## Product Change Notification - ELA-TR4-4G-CFGXXX

PCN221010-ELA-TR4-4G

ELA-TR4-4G actuators produced from september 2022 onwards

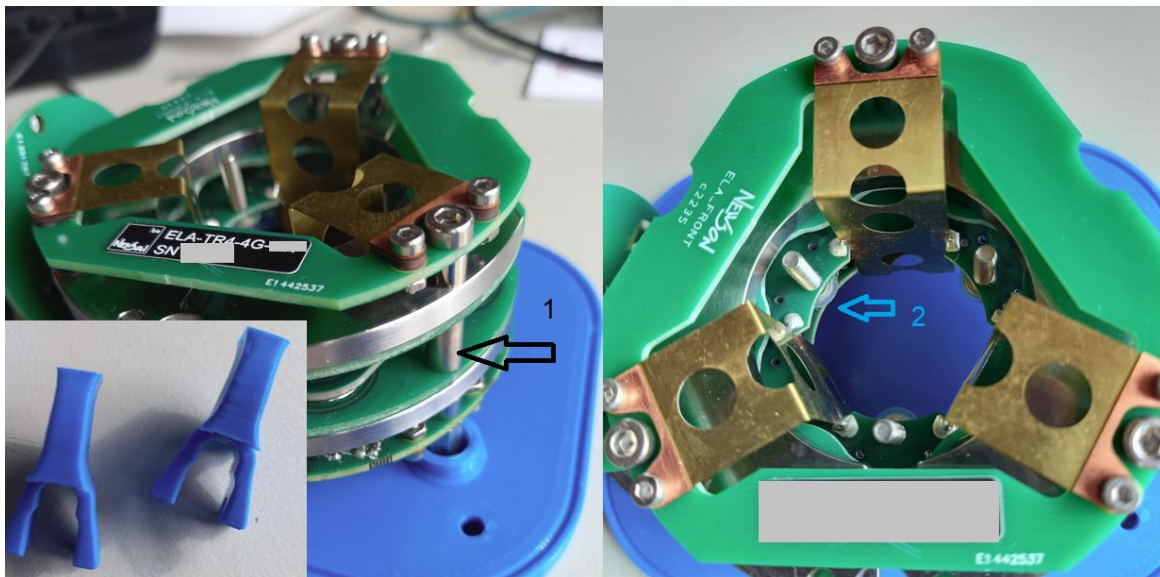
1. Custom drilled hexagon standoffs have been replaced by standard round standoffs in order to simplify production. New fix tools are available which align around the round standoffs.
2. The 3 screws used to mount the moving lens are not sealed anymore into the PCB. This alteration eliminates possible evaporation of the adhesive onto the optics.

Both changes have no impact on the dynamics of the actuator
